**BEFORE THE OFFICE OF THE REGIONAL FORESTER
REGION ONE – USDA FOREST SERVICE
Objection Reviewing Officer**

**NOTICE OF OBJECTION
PURSUANT TO
36 CFR 218**

Weed Lake Landscape Restoration Project Draft Decision Notice and Finding of No Significant Impact (hereafter Project, DN and FONSI)
Chip Weber, Flathead Forest Supervisor, July 2018.

Figure 30. Weed lake proposed action

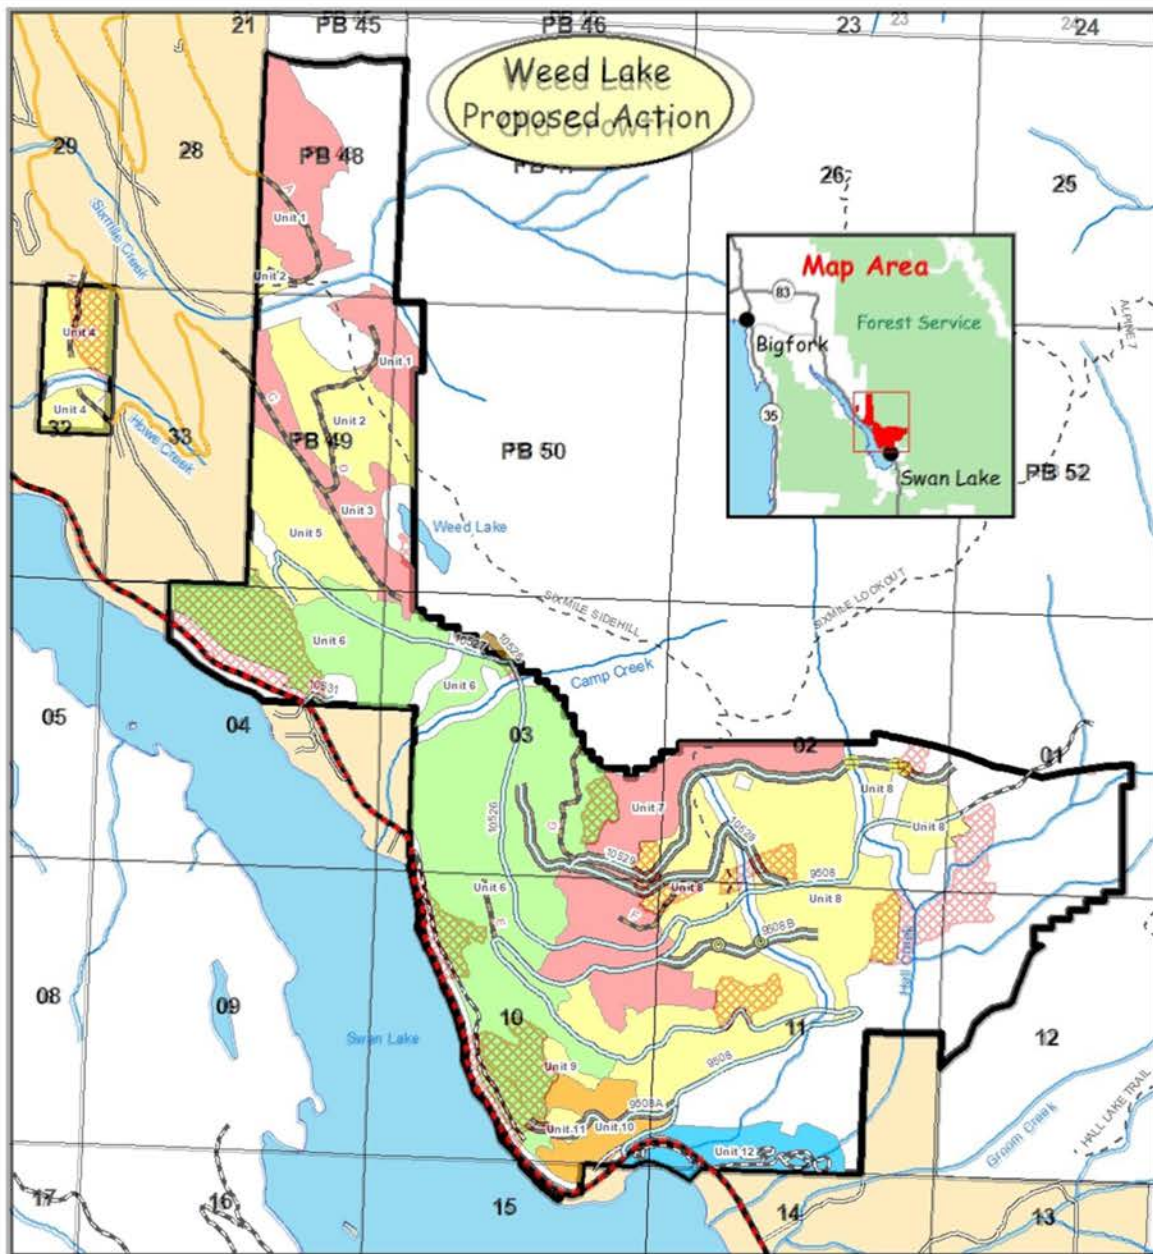
4. Nor does the existing old growth present any proximate threat of carrying wildfire to existing structures. We’ve attached to this Objection two overlays of EA Maps: a) an overlay of Maps 3 and 5, showing Cutting Units and Old Growth and b) an overlay of Maps 5 and 6, showing Structures and Old Growth.

5. The above maps show most old growth is far distant from human structures. In the few instances where it is close to human structures, it is across a major highway corridor. These human structures (red dots) are at more risk of fire initiated within the highway corridor (cigarette butts, dragging trailer chains, etc.) than from any wildfire in old growth across the highway corridor. There is no reason to treat/log in old growth.
